TOPIC: 494 S Broadway Site Plan Review

494 S. Broadway - Cloud Retail - Site Plan Review #3 - March 28, 2023

Subject: 494 S. Broadway Street (M-24): Cloud Retail - Site Plan Review #3

NORTH ELEVATION
SCALE: 3/16" = 1'-0"

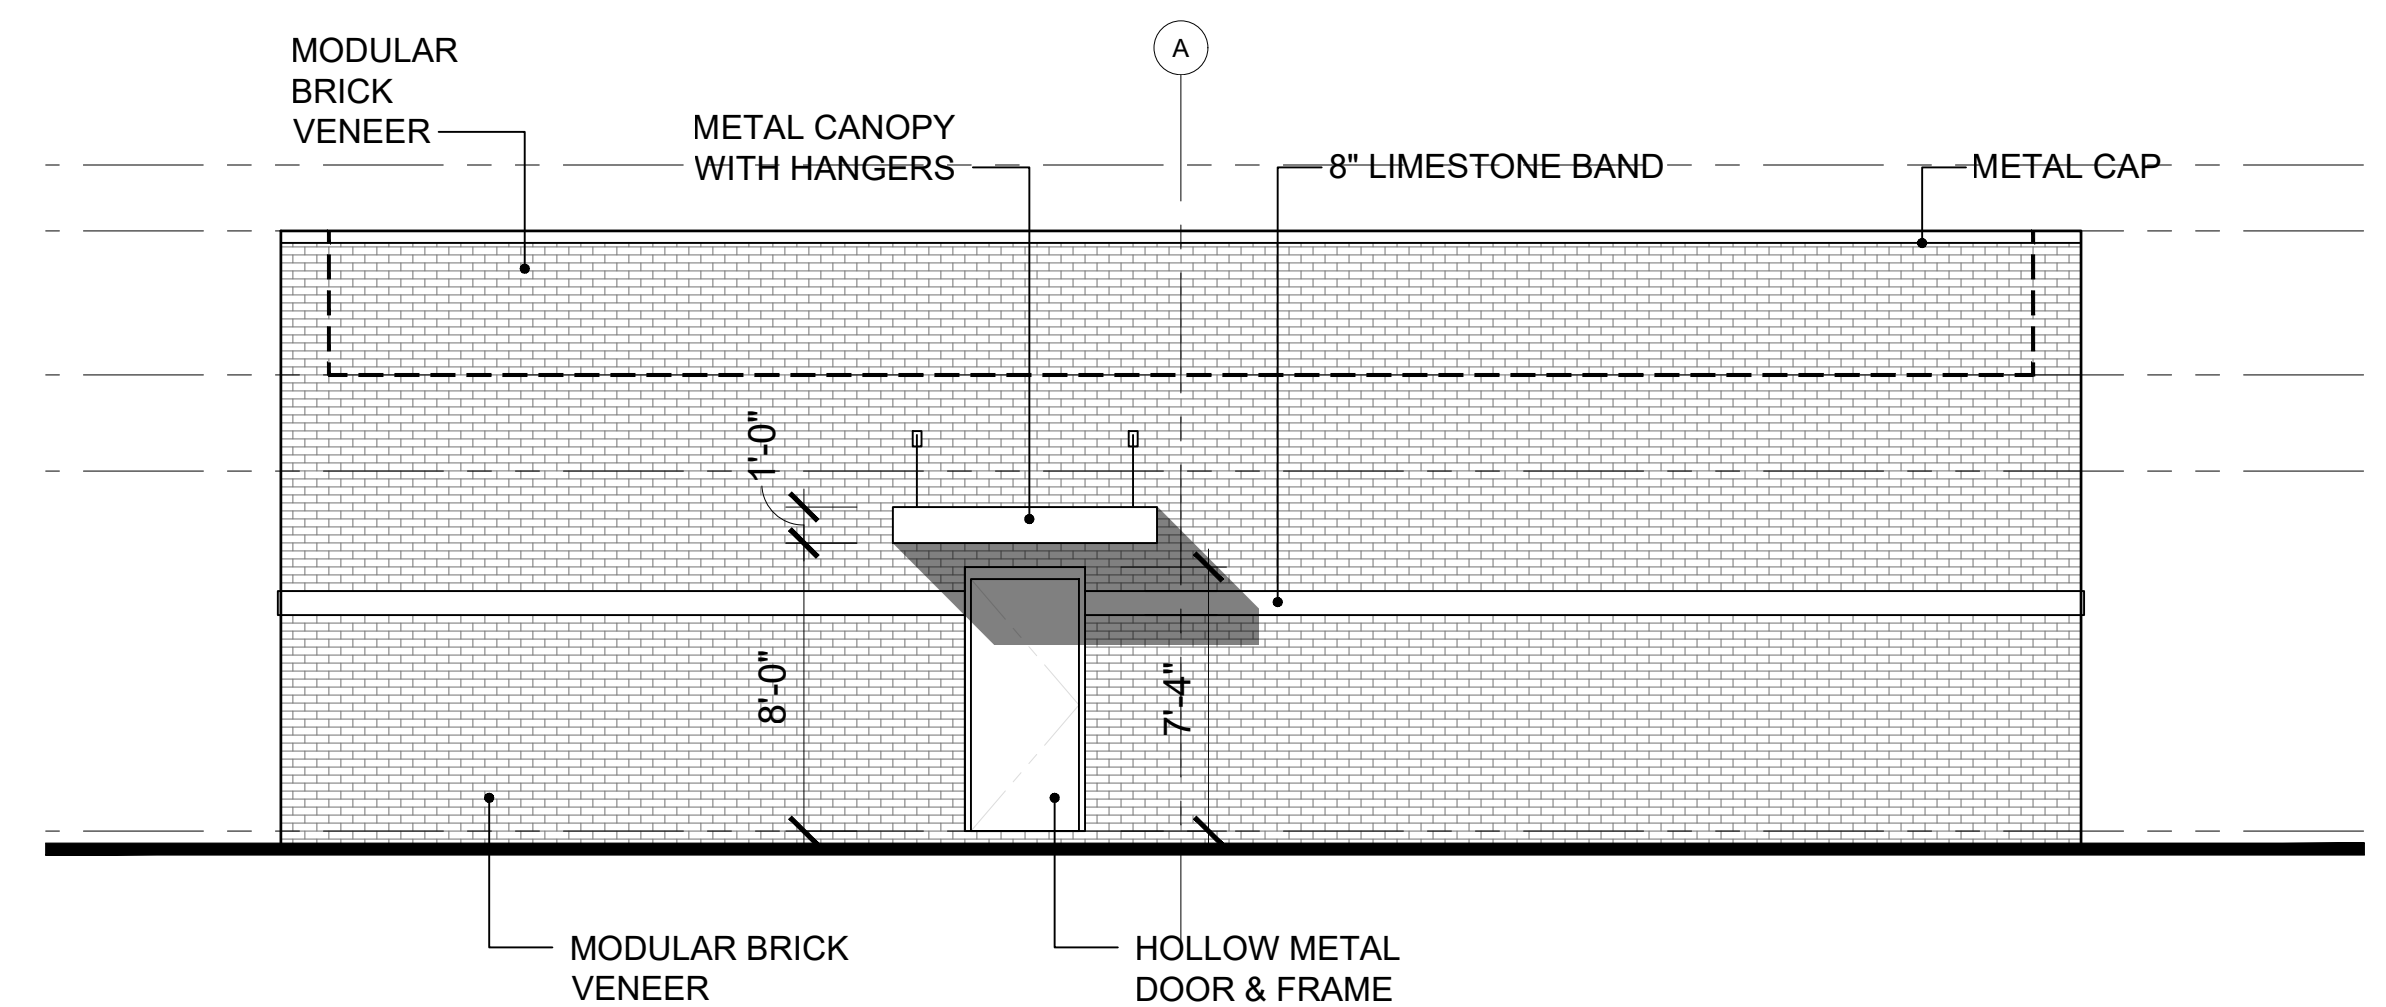
The applicant proposes a building clad largely in brick veneer with limestone banding, fiber cement panel accents, and a metal canopy. Additional glazing is proposed for the north and east elevations. Material samples have been provided to the Planning Commission, approving the applicant's selection.
- Signage.** The location of a proposed monument sign is also detailed along S. Broadway; this sign will also be reviewed and permitted under separate application; no signage is approved as part of this site plan.

decorative sconce lighting for the north and east elevations, as seen on Sheet A3.1. A cut sheet for the sconces must be provided and these fixtures must be reflected on the photometric plan, which still shows the previous wall packs and incorrect fixture locations and mounting heights.

1 KNEEWALL DETAIL - SECTION
SCALE: 1/2" = 1'-0"

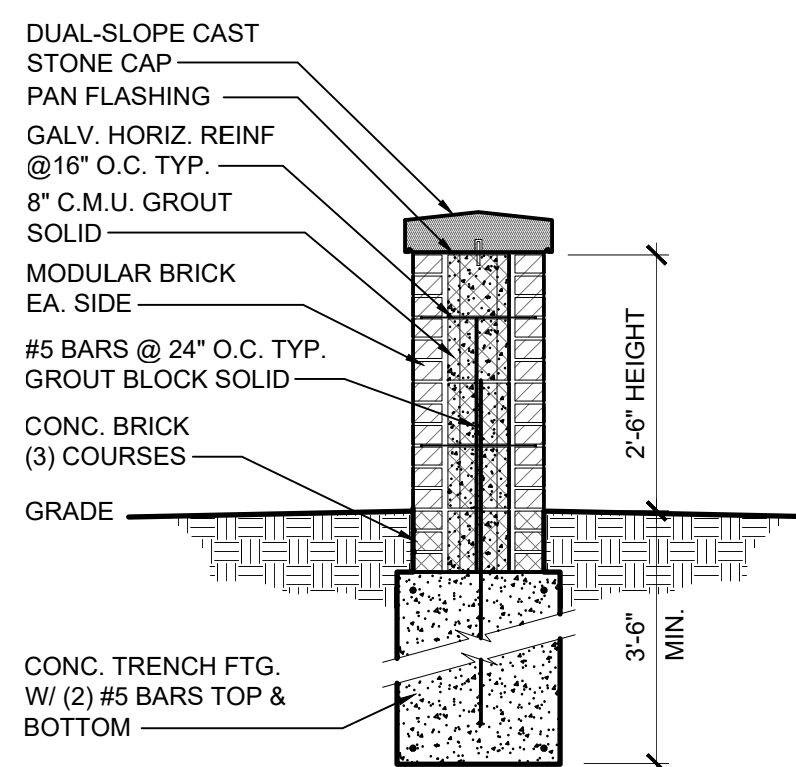
between the parking lots and Heights Road and Broadway to create a uniform, year-round screen. We find that the additional grasses and knee wall will provide a complementary screen to the parking lots. A note must be added that the knee-wall will match the material and color of the building.
